SERVICE BULLETIN # 1043

MODEL **S44A**, S55A, S44 and S55

SUBJECT **BETTER FRAME BRACE CLAMP ATTACHMENT**

FIGURE 1

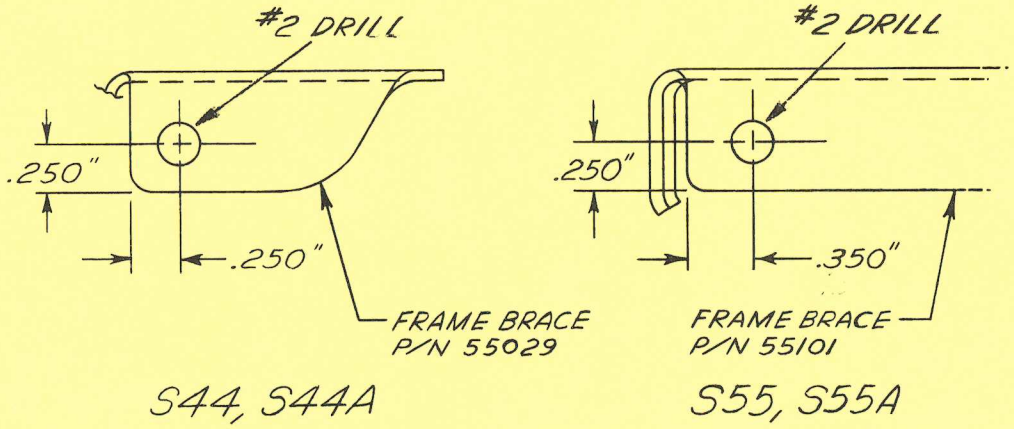
To prevent the frame brace clamp from slipping off the frame brace, drill a mounting hole through each side of the frame brace at the location shown in Figure 1.

FIGURE 2

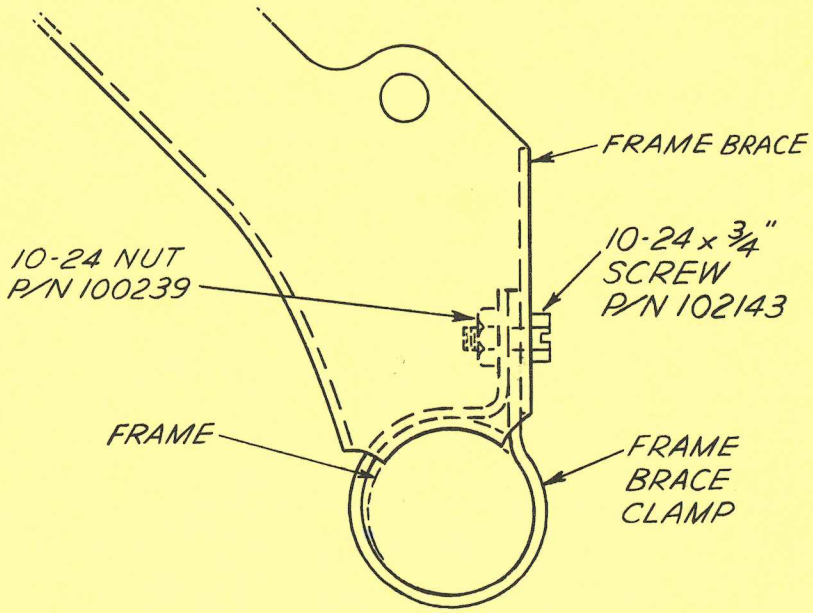
Install the clamp on the frame brace with the screw head on the outer side of the mounting hole as shown in Figure 2.
